Application of PACIFIC GAS AND ELECTRIC COMPANY for a Class 104b. License to Construct and Operate a Nuclear Reactor as a Part of Unit No. 3 of Its Humboldt Bay Power Plant

Docket No. 50-133 Amendment No. 9

ADDENDUM H

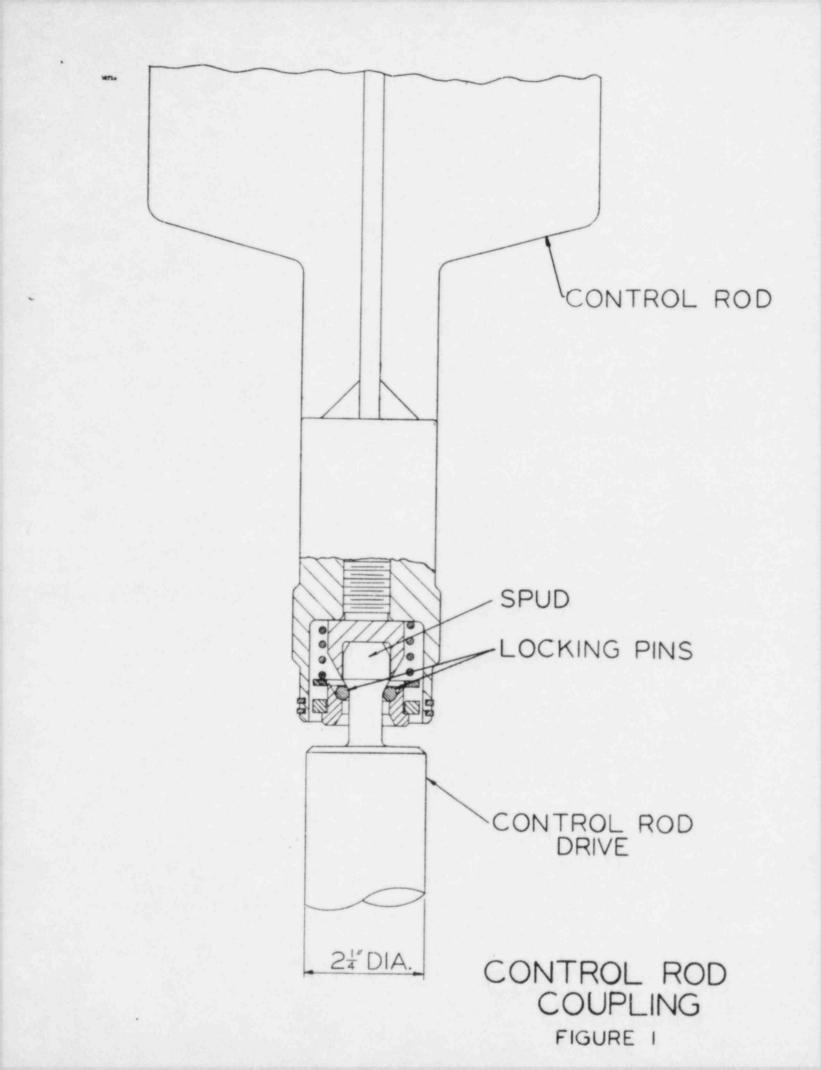
The coupling, which is shown in Figure 1, attaches to the drive by the locking pins moving up and out as pressure is supplied to the pins by the spud entering the socket. These pins are forced in behind the spud after the spud enters the socket locking coupling to spud. The force required to engage the coupling on the spud is approximately 1/8 the weight of the control rod, thus whenever the control rod is set in place on top of the drive, the coupling will automatically engage.
